Technical Service Bulletin (TSB)

Improperly Installed Wastegate Rod Retention Clips

REFERENCE:	TSB: 09-008-25 REV. B GROUP: 09 - Engine	Date:	July 2, 2025	REVISION:	09-008-25 REV. A
VEHICLES AFFECTED:	2025 (DT) RAM 1500 Pickup This bulletin applies to vehicles built on or after June 01, 2024 (MDH 0601XX) and on or before March 03, 2025 (MDH 0325XX) equipped with the 3.0L I6 Hurricane HO Twin Turbo ESS (Sales Code EFC).			MARKET APPLICABILITY: ☒ NA☐ MEA ☐ EE☐ IAP ☐ SA☐ CH NOTE: **This bulletin applies to North America markets. **	
CUSTOMER SYMPTOM:	Customers must experience a Malfunction Indicator Lamp (MIL) illumination and the vehicle must exhibit/set one or more of the following Diagnostic Trouble Codes (DTCs): - P0248-00 - Turbocharger-Supercharger Wastegate Actuator B Range-performance. - P2B94-00 - Wastegate Position Sensor B Exceeded Learning Limit. Customers may also experience the following: - Lack of acceleration from the turbo.				
CAUSE:	Incorrectly installed wastegate rod retention clips

Fig. 1
Wastegate Rod Retaining Clips

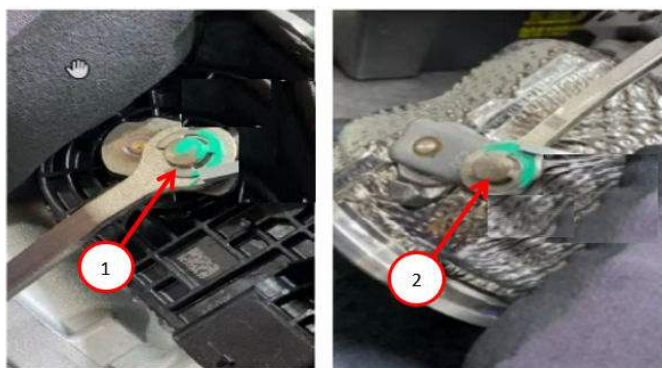
3. Using a caliper, measure the dimensions of the two wastegate rod retaining clips on the actuator side [Fig. 1](#).

4. Is the measurement of either wastegate rod retaining clip on the actuator side greater than 13.70 mm **** (0.538 in.)****?
 - YES>>> Proceed to [Step 5](#).

6. Using a caliper, measure the dimensions of the two wastegate rod retaining clips on the housing side [Fig. 1](#).
7. Is the measurement of either of the wastegate rod retaining clips on the housing side greater than 17.78 mm (0.7 in.)?

- NO>>> Proceed to [Step 6](#).
5. Replace any wastegate rod retaining clip on the actuator side that measures larger than 13.70 mm **** (0.538 in.)****.

8. Replace any wastegate rod retaining clip on the housing side that measures larger than 17.78 mm (0.7 in.).
9. Install the clean air tube. Refer to the detailed service procedures available in DealerCONNECT/Service Library under: Service Info> 09 - Engine, 3.0L GMET6 / Air Intake System / Tube, Intake Air / Installation.
